GROUP	MODEL
Noncompliance Safety Recall Campaign	2022-2023MY Sorento (MQ4a) Sorento P/HEV (MQ4 P/HEV)
NUMBER	DATE
SC280	October 2023

REAR VIEW CAMERA MOUNTING BASE REPLACEMENT (SC280)

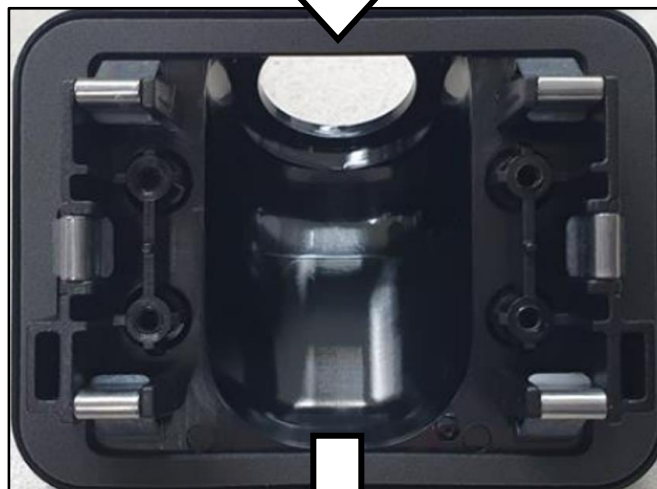
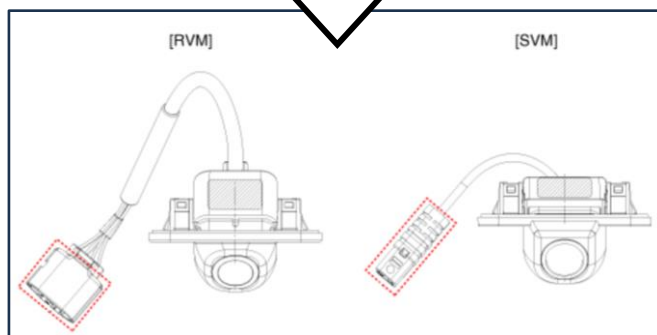
7. Replace the existing rear view camera mounting base (E) with the new mounting base E), RVM or SVM as applicable.

Note: The two (2) different rear view camera mounting bases:

- RVM (Rear View Monitor)
- SVM (Surround View Monitor)
